ARKANSAS NUCLEAR ONE - UNIT 1

AMENDMENT TO FACILITY OPERATING LICENSE

Amendment No. 2
License No. DPR-51

CHANGE NO. 2 TO THE TECHNICAL SPECIFICATIONS

ARKANSAS POWER & LIGHT CO ARKANSAS NUCLEAR ONE-UNIT 1	OPERATIONAL POWER IMBALANCE ENVELOPE	FIG. NO. 3.5.2-3
--	---	---------------------

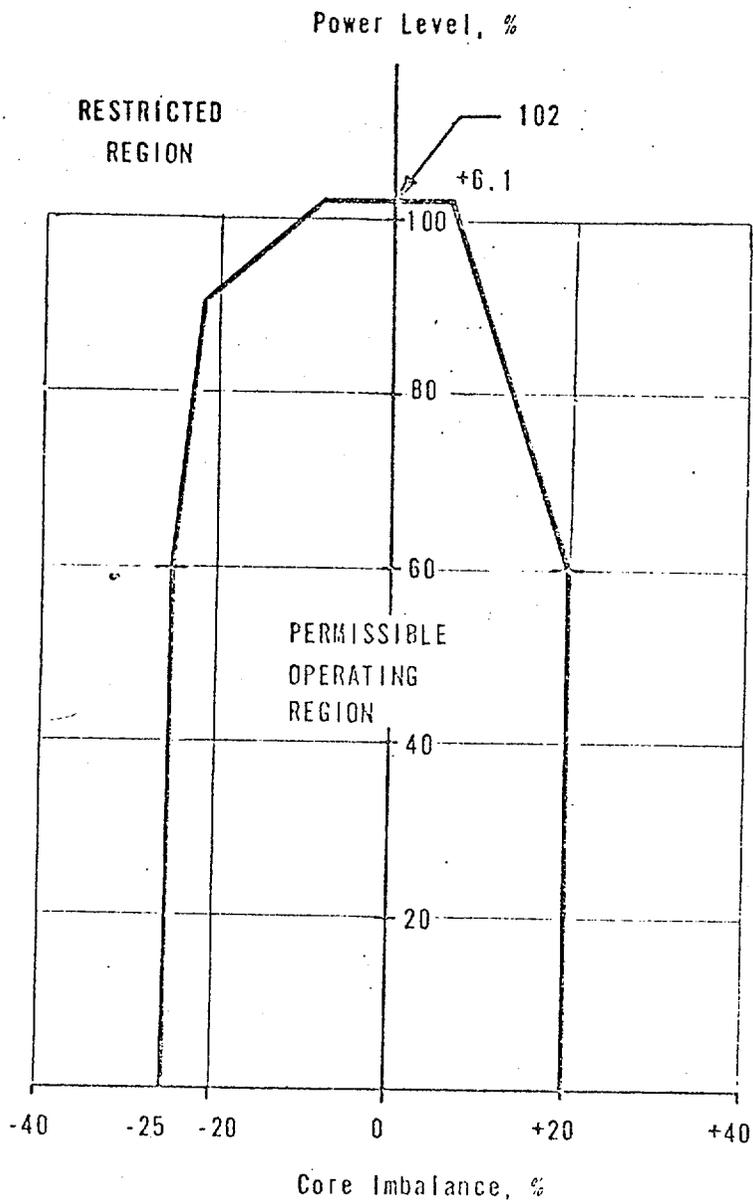
- (5) Figure No. 3.5.2-3 - The change in the permissive operating region for power imbalance reduces the allowable operation to be compatible with the protective system maximum allowable setpoints. The change to this figure does not change the allowable reactor operation since the reactor had to be operated within the more restrictive limits established for the reactor protective system. The change is acceptable.

- (5) Figure No. 3.5.2-3 - The change in the permissive operating region for power imbalance reduces the allowable operation to be compatible with the protective system maximum allowable setpoints. The change to this figure does not change the allowable reactor operation since the reactor had to be operated within the more restrictive limits established for the reactor protective system. The change is acceptable.
